Work Order ID 154606

Item Name: Baggage Compartment Protector - Floor

DART SERVICE INSTRUCTION

TO AMEND INSTALLATION INSTRUCTIONS IIN-D407-781-2 REV. A OR LATER APPROVED REVISION
AND INSTRUCTIONS FOR CONTINUED AIRWORTHINESS ICA-D407-781 REV. 3 OR LATER REVISION

FIGURE 1 - D3879-1 BAGGAGE COMPARTMENT WALL PROTECTOR - ALTERNATE INSTALLATION

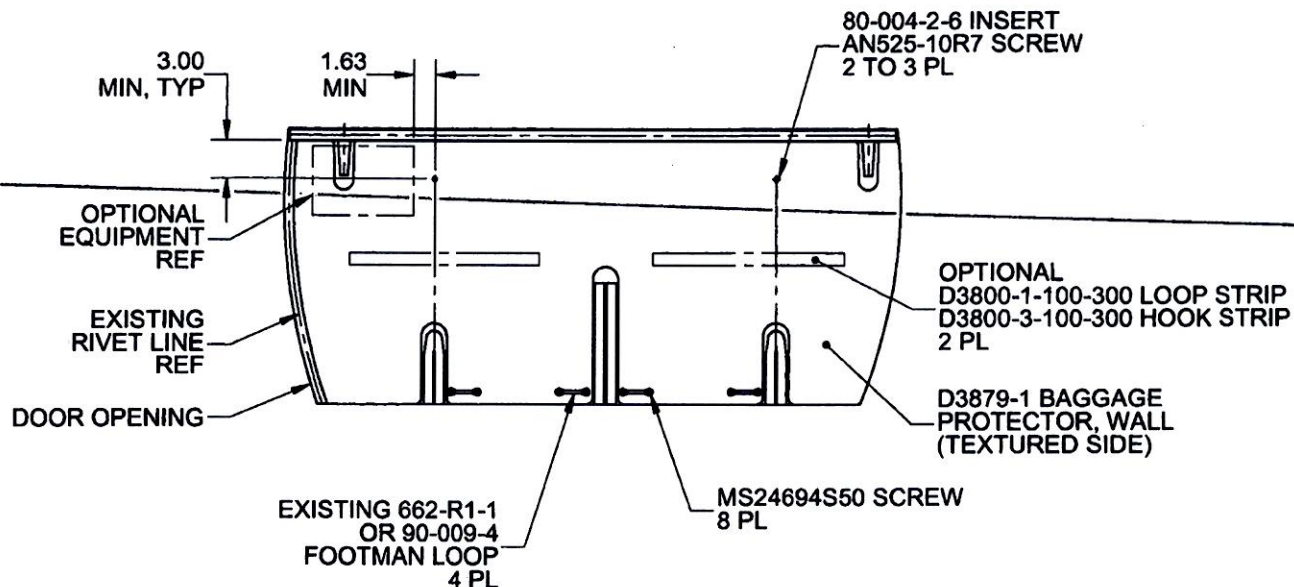
In some aircraft, the top portion of the D206-781-041 Baggage Compartment Wall Protector Kit cannot be installed as indicated in IIN-D407-781-2. The purpose of this DSI is to provide an alternate mounting method to fasten the top portion of the D206-781-041 Baggage Compartment Wall Protector Kit.

It is acceptable to replace qty(2) D3930-1 Clips with qty(2) 80-004-2-6 Inserts. Locate and mark location of the two attachment holes on the baggage compartment wall as shown in Figure 1 of this service instruction. Install 80-004-2-6 Inserts at the marked locations in accordance with Section 3-2-12 of BHT-206-SRM-1. It is acceptable to trim the wall protectors to accommodate optional equipment or transfer attachment holes to the wall protector and install the optional equipment on top of the wall protector with longer fasteners.

Amend the D206-781-041 Baggage Compartment Wall Protector Kit parts list as follows:

Qty -061	Qty -031	Qty -041	Part Number	Description
X			D206-781-061	BAGGAGE COMPARTMENT PROTECTOR KIT (FLOOR AND WALL)
1	X		D206-781-031	BAGGAGE COMPARTMENT FLOOR PROTECTOR KIT
1		X	D206-781-041	BAGGAGE COMPARTMENT WALL PROTECTOR KIT
		2	AN525-10R7	SCREW
		2	80-004-2-6	INSERT
